# Peer Review

Moorabool Shire Flood Studies

V170467

## **Attachment 1: Peer Review – Moorabool Shire Flood Studies**

Figure 4-2 Exhibited SBO Extent, near Masons Lane

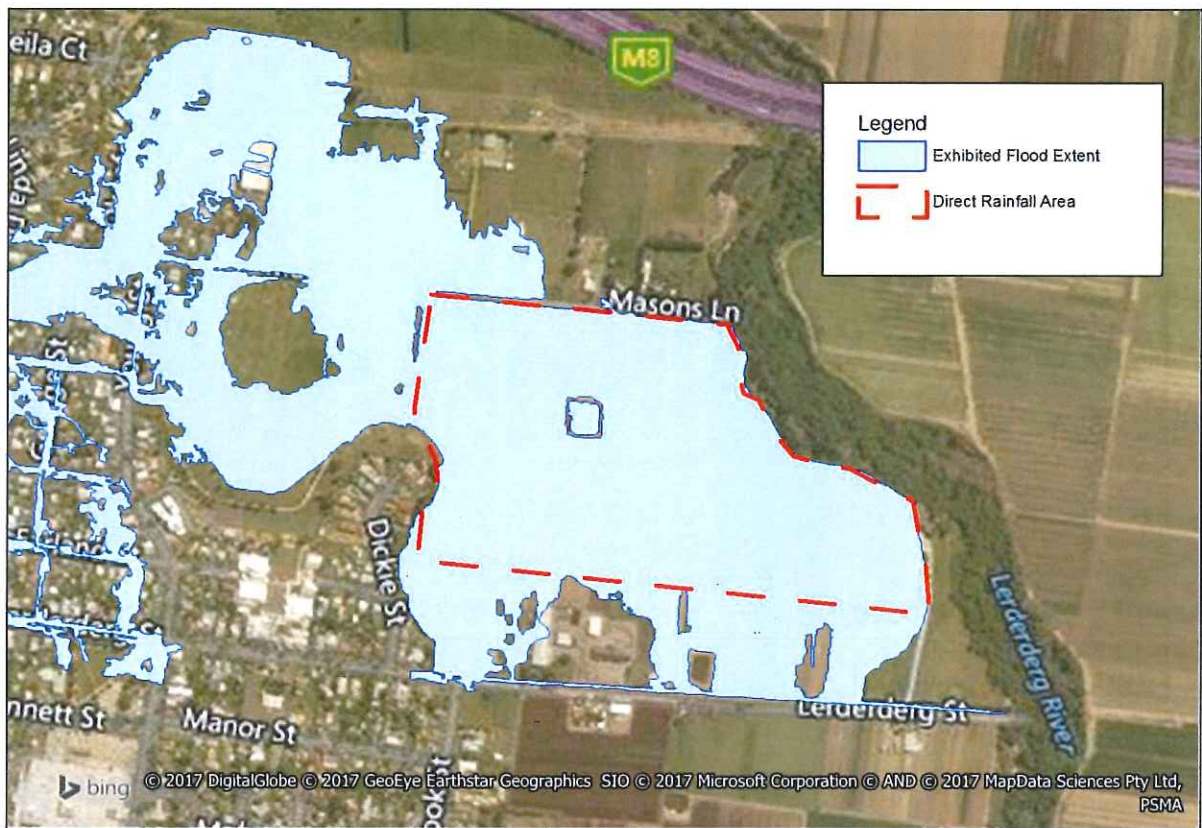
- > It was noted that the flood extent as exhibited, south of the Western Freeway, covers the entirety of the farming land between Mason's Lane and Lerderderg Street as shown in Figure 4-2. This flood shape does not match that shown in the Engeny report for this location (Figure 1 in the Engeny report, reproduced here as Figure 4-3). This is likely due to the flood extent in this area being created using a process that is now deprecated by Melbourne Water.

In our view, flood extents generated using the point density method should not be used in planning scheme overlays. It is recommended that the flood extents generated in the Lower Lerderderg catchments be re-examined and updated as necessary based on Melbourne Water's updated process to determine flood extents. The appropriate starting point would be the flood extents shown in the Lower Lerderderg Catchments Flood Mapping report, Figures 1 and 2.

Cardno considers that the proposed SBO extent does not appropriately reflect the results of the flood modelling for the Lower Lerderderg area. The proposed SBO should be modified to reflect the actual results of the flood modelling.

The flood extents created by Melbourne Water for Lower Lerderderg study area should not be used as the planning overlays. The proposed flood extents and the resulting SBO shapes in these areas should be recreated based on the model results using appropriate filtering techniques, such as those described in Melbourne Water's 2016 technical specifications.

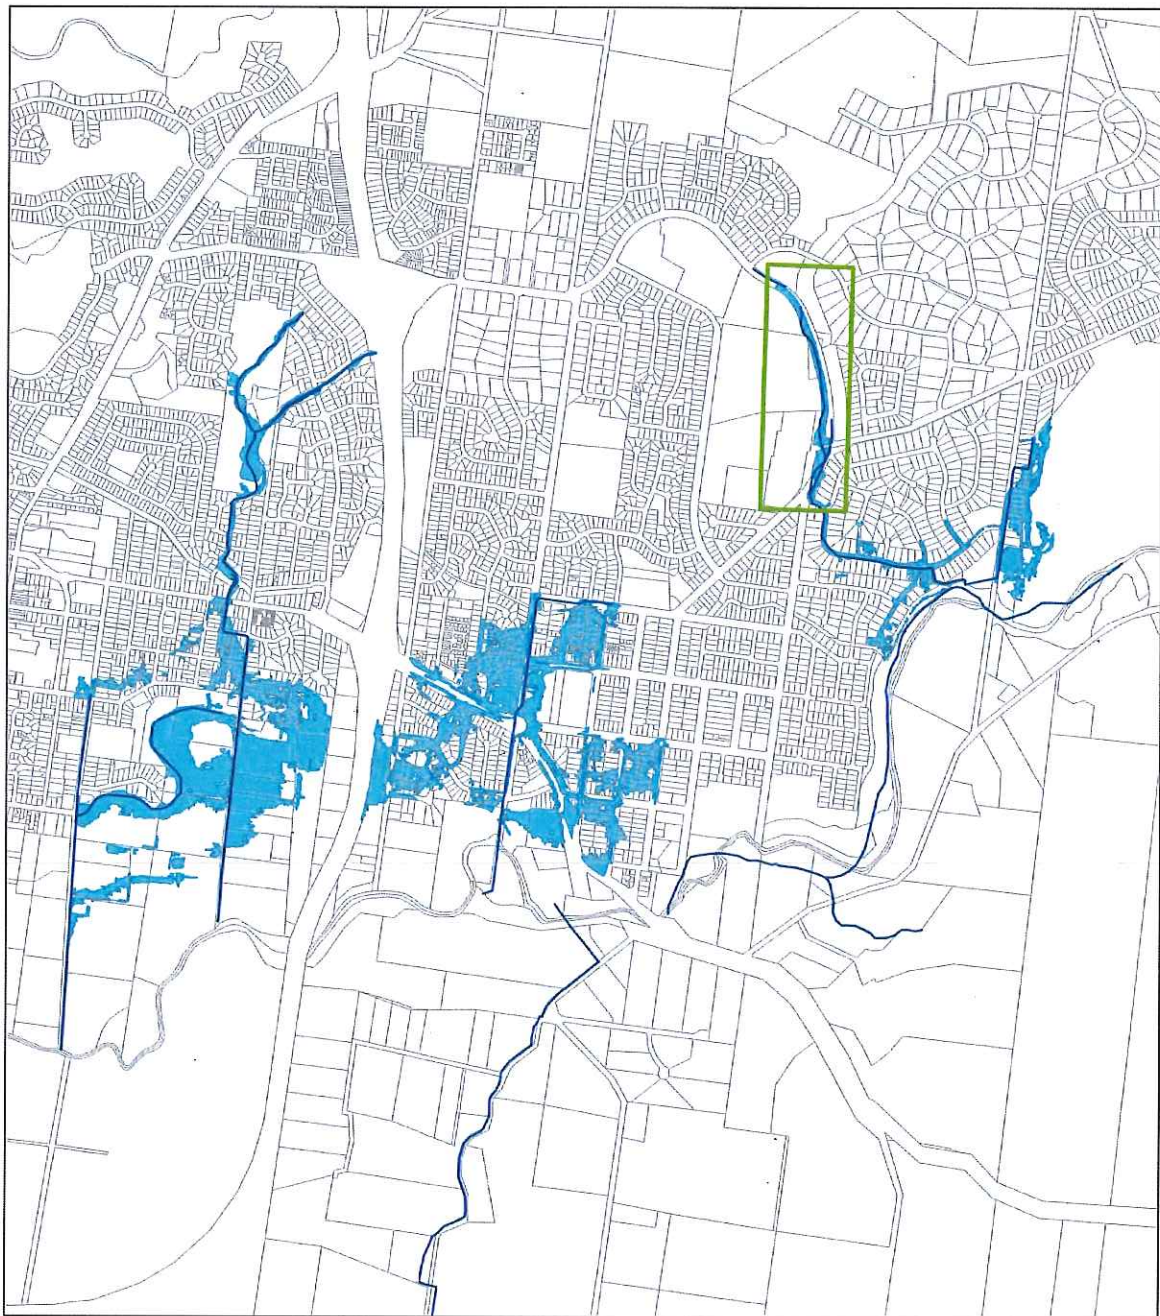
The revised Special Building Overlay is shown on Figure 4-1 overleaf.

It is recommended that the proposed SBO is adopted and the planning scheme amendment process be recommenced.

Figure 4-2 Overlay Comparison

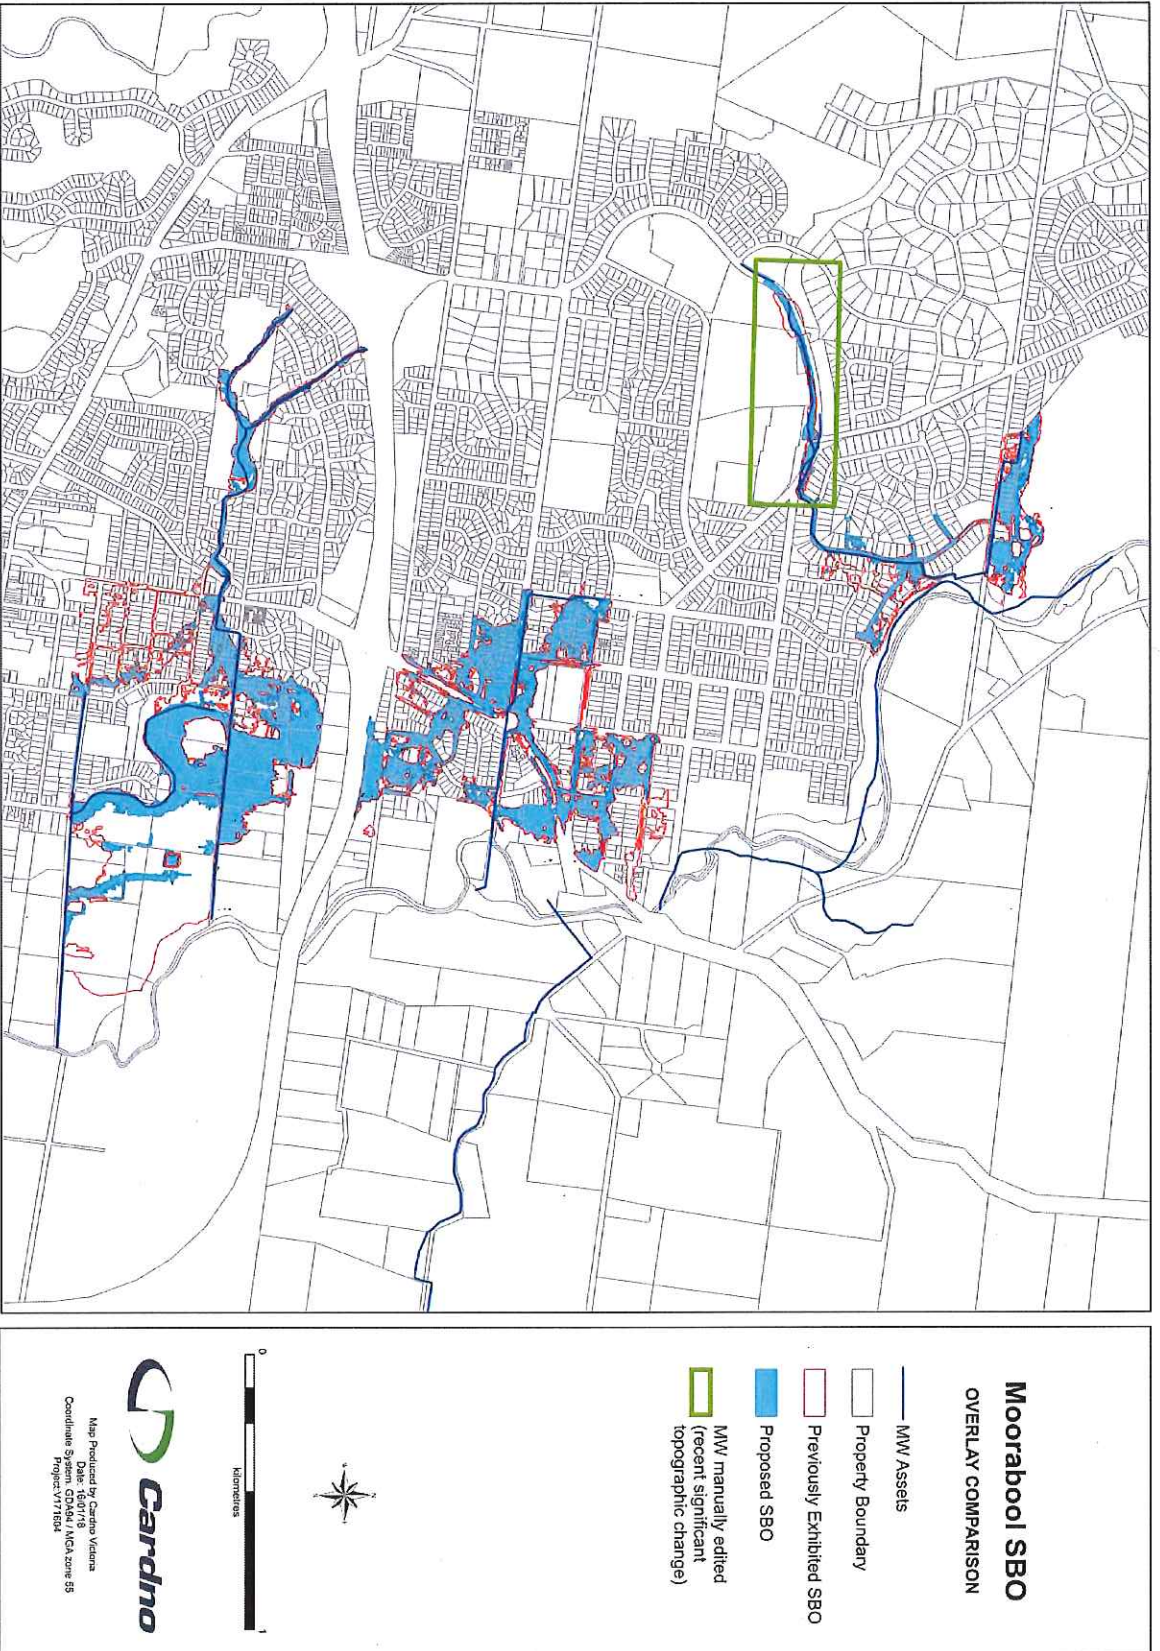
Figure 4-2 shows this proposed overlay alongside the previously exhibited overlay. Whilst there are a number of changes, the key area of change is in the rural land south of Masons Lane. The proposed overlay is significantly reduced from that which was previously exhibited.
